Notice of Allowability	Application No.	Applicant(s)	
	10/646,044	CHEMELEWSKI, DAVID	
	Examiner	Art Unit	
	Benjamin C. Lee	2632

EXAMINER'S AMENDMENT

Proposed Fig. 1 approved by Examiner

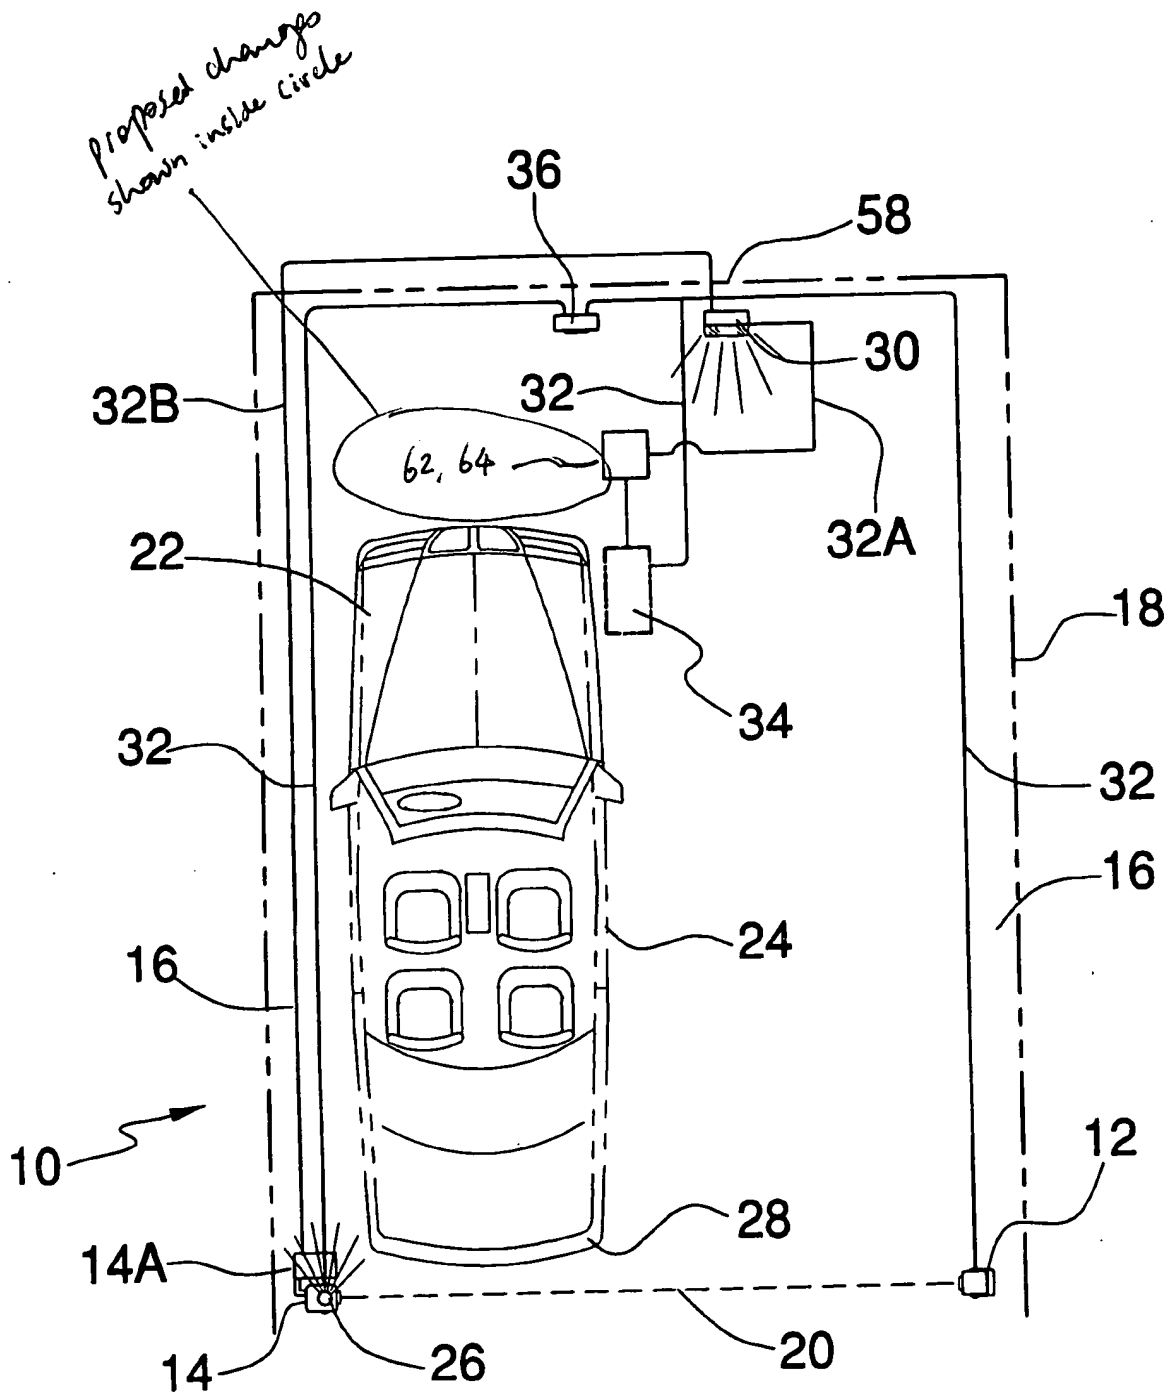
2. The following changes to the drawings have been approved by the examiner: 1) In Fig. 1, the labels "62" and "64" have been attached to the unlabeled box situated between 30 and 34; 2) In Fig. 3, label "36" has been changed to --30--. See Attachment. Note that **all drawings and changes** have to be based on the original figures filed 8/22/03 as opposed to Applicant's later filed drawings which looked different from the original figures and thus containing new matter (i.e. Figs. 1-2). Only new drawing sheets containing amended figures 1 and 3 need be submitted,

Proposed Fig. 3 approved by Examiner

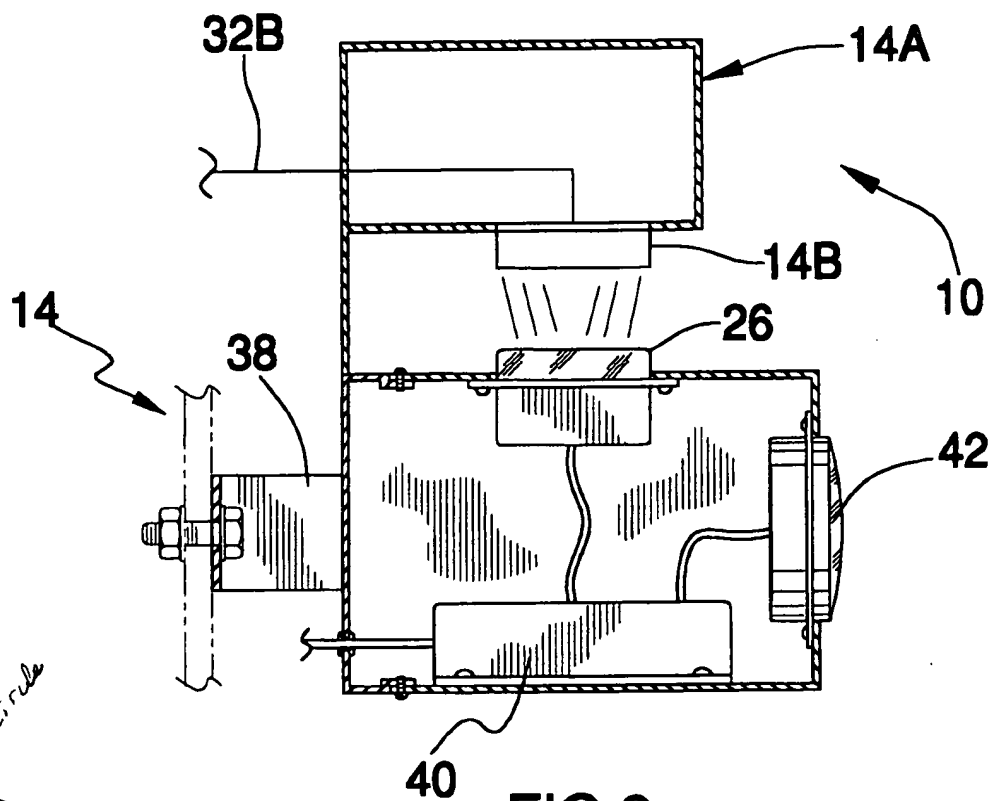
Proposed change
shown inside circle
